Access Compliance Report

Public Rights-of-Way

(Curb Ramps)

Intersection ID: 49184	Main Street: ST_GERMAINE_LN	Cross Street: ST_STEPHEN_LN	Location: NE
ADA ID: D6834F5EA36D	Ramp Type: PerpDiag	Initial Pass/Fail: Fail	Overall Compliance: No
Severity Score: 35			
Codes/Mitigation Info/Possible Solution		Field Measurements/Component Compliance

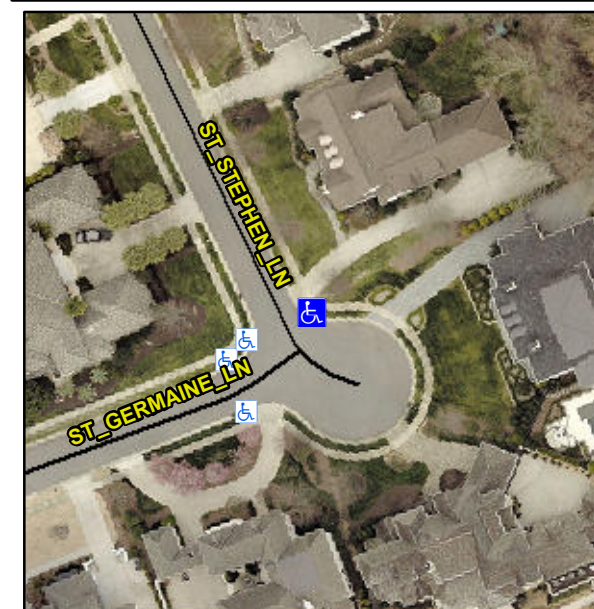
Remove & Replace Curb Ramp With Two New Directional Ramps or Equivalent.

R304.5.1, R304.2.2, R304.5.3

Compliance	Description	Data	Compliance	Description	Data
N/A	Ramp Length (in)	52.0	No	Ramp Slope (%)	13.5
No	Ramp Width (in)	47.5	No	Ramp XSlope (%)	3.3
N/A	Flare Type LT	N/A	N/A	Flare Type RT	N/A
N/A	Flare Slope LT (%)	N/A	N/A	Flare Slope RT (%)	N/A
N/A	Flare Traversable LT?	N/A	N/A	Flare Traversable RT?	N/A
N/A	Landing Length (in)	N/A	N/A	DWS Provided?	N/A
N/A	Landing Width (in)	N/A	N/A	DWS Contrast?	N/A
N/A	Landing Slope (%)	N/A	N/A	DWS Length (in)	N/A
N/A	Landing X Slope (%)	N/A	N/A	DWS Full Width?	N/A
N/A	Landing Curb? (Y/N)	N/A	N/A	DWS Offset (in)	N/A
N/A	Shared Landing?	N/A			
N/A	Gutter Ponding?	N/A	N/A	Gutter Slope (%)	N/A
N/A	Gutter Lip Ht (in)	N/A	N/A	Gutter X Slope (%)	N/A
N/A	Painted X Walk1?	No	N/A	Painted X Walk2?	No
	X Walk 1 Direction	To W		X Walk 2 Direction	To S
N/A	X Walk 1 Width (in)	N/A	N/A	X Walk 2 Width (in)	N/A
	X Walk 1 Slope (%)	3.0		X Walk 2 Slope (%)	1.3
	X Walk 1 X Slope (%)	1.2		X Walk 2 X Slope (%)	1.3
